**The Scottish Government
Energy Consents Unit**

**Scoping Opinion On Behalf Of Scottish Ministers Under The
Electricity Works (Environmental Impact Assessment) (Scotland)
Regulations 2017**

**Creag Dhubh to Dalmally 275kV Connection
Scottish Hydro Electric Transmission PLC**

8 March 2022

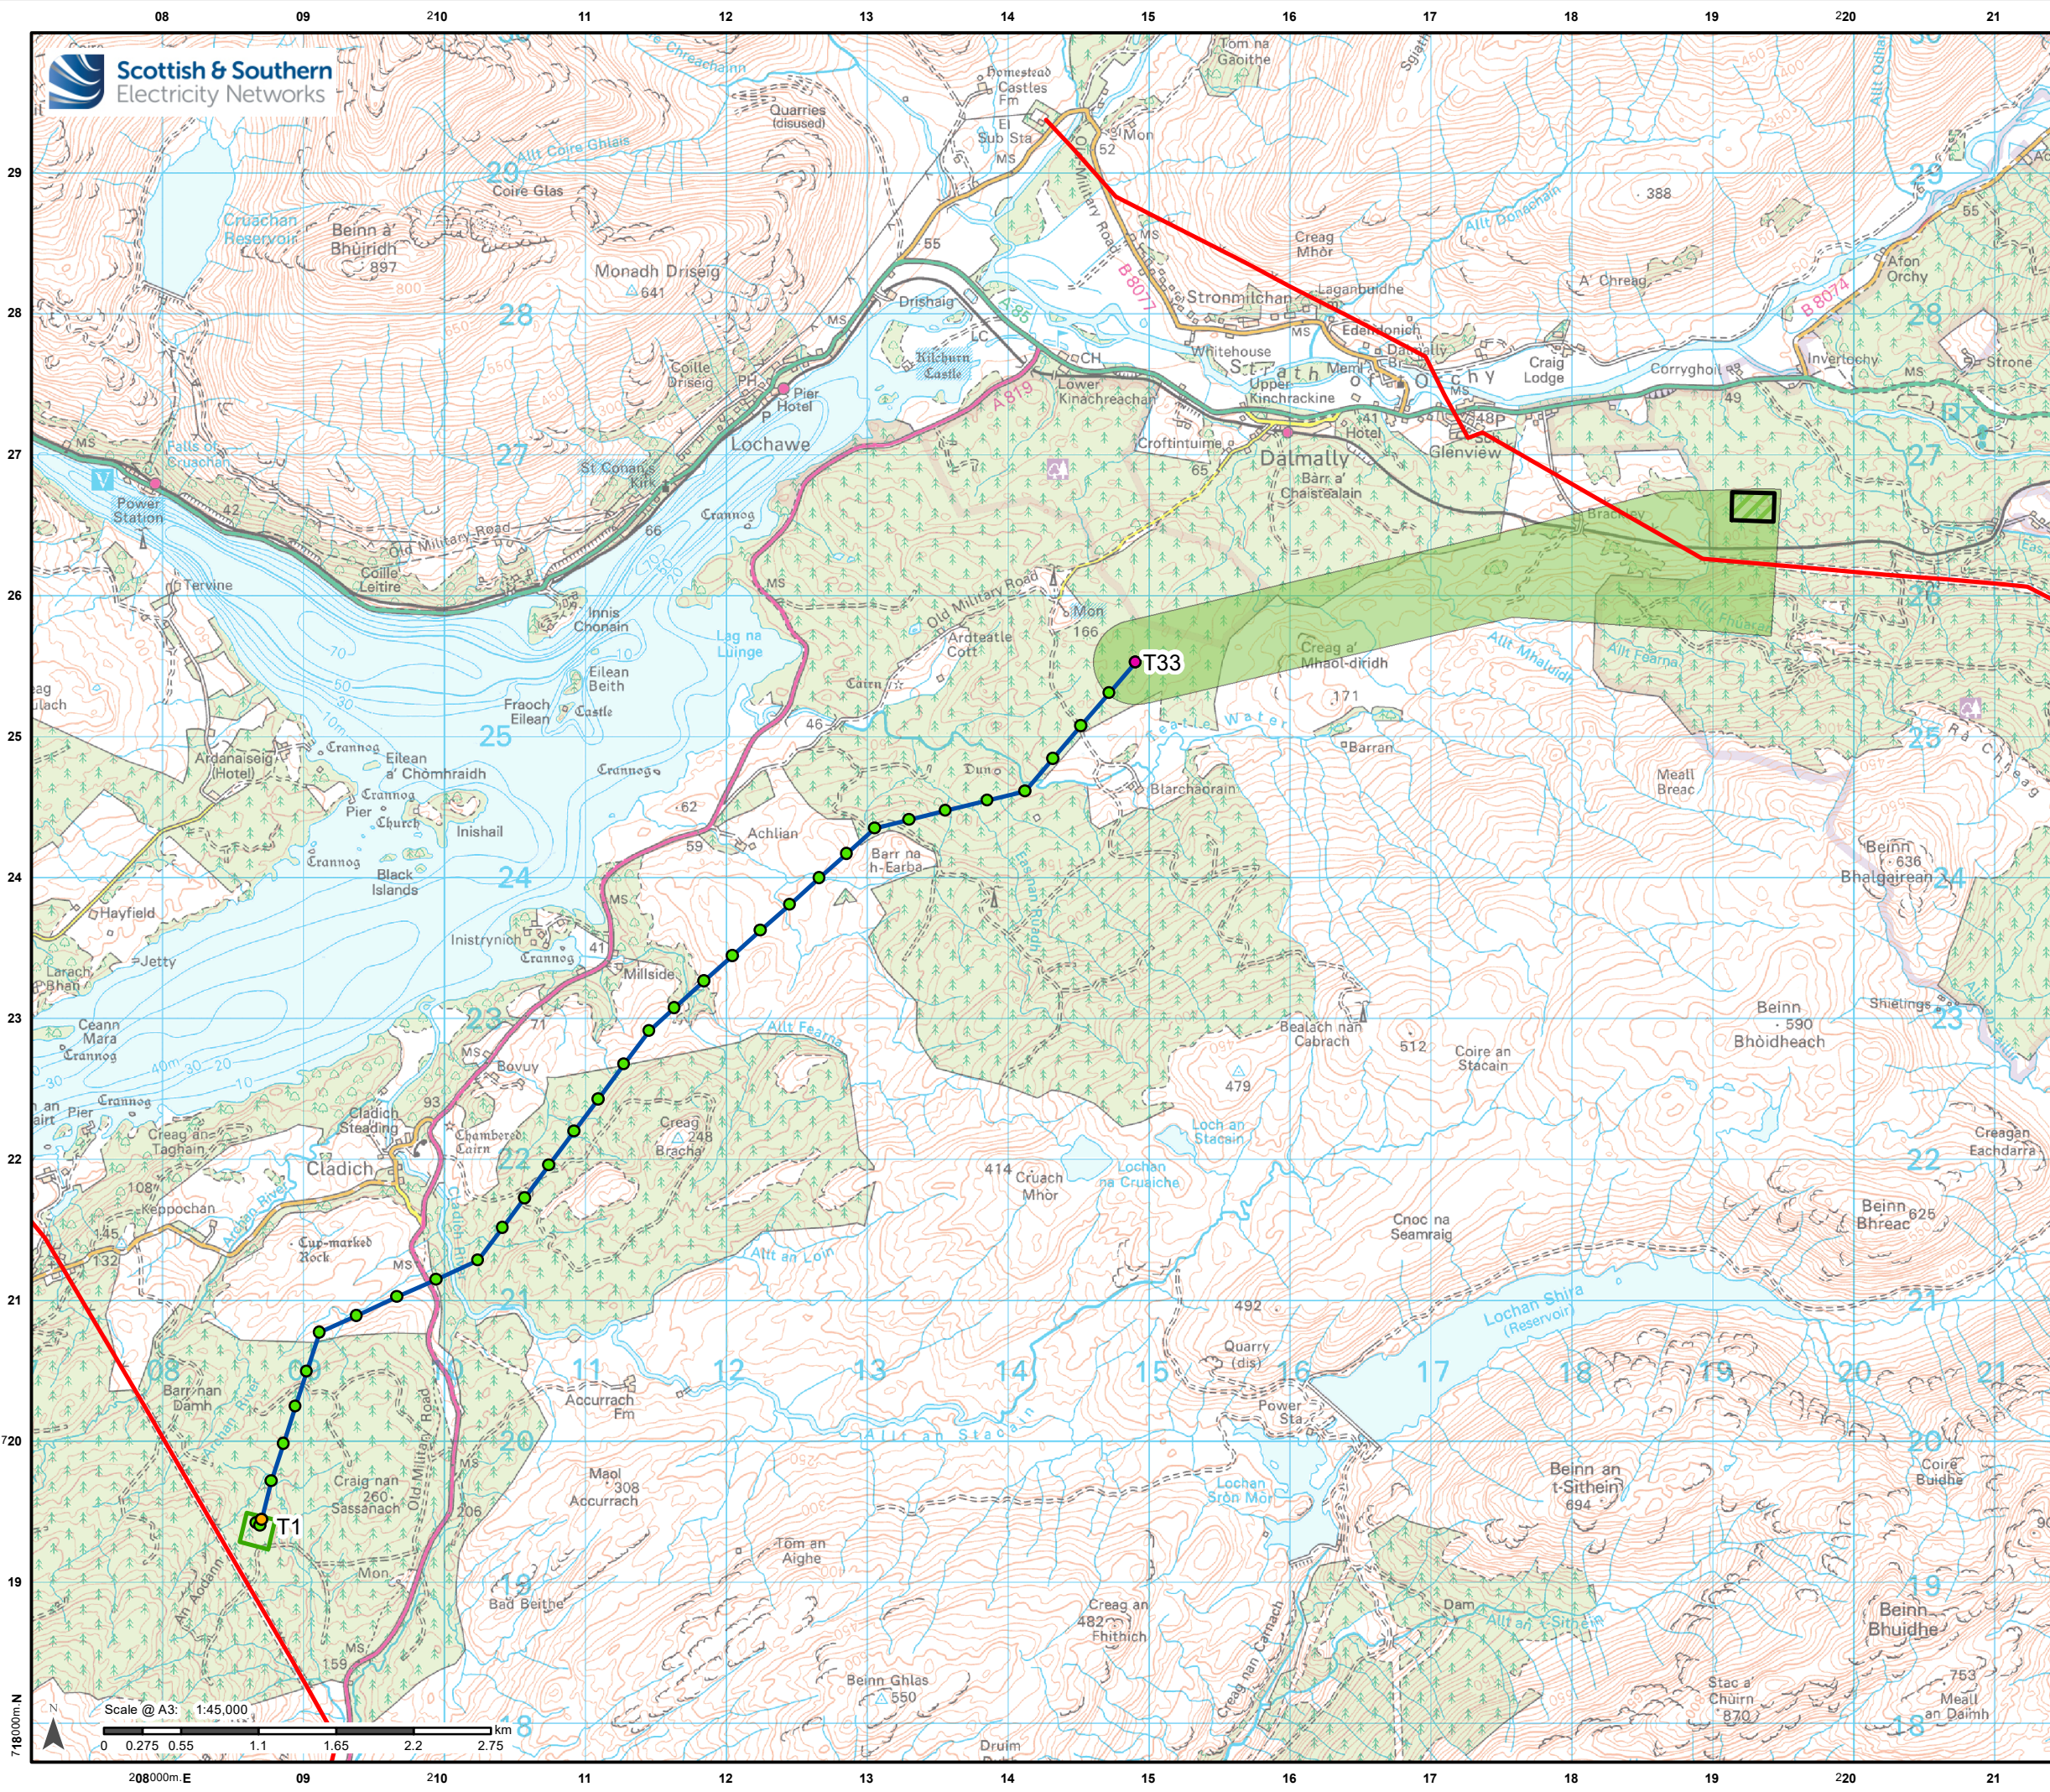
We have assumed a maximum Tower Height of 60m as indicated in section '2.4 Indicative Overhead Line Design' of the scoping report. Tower Number 18 runs directly under BT Radio Link 6140 from DALMALLY POLICE SITE to KILCHRENAN TE. If these Tower heights increase above 60m you will need to resubmit your proposal and BT will reassess the impact accordingly.

With the Tower Height at 60m the conclusion is that, the Project indicated should not cause interference to BT's current and presently planned radio network.
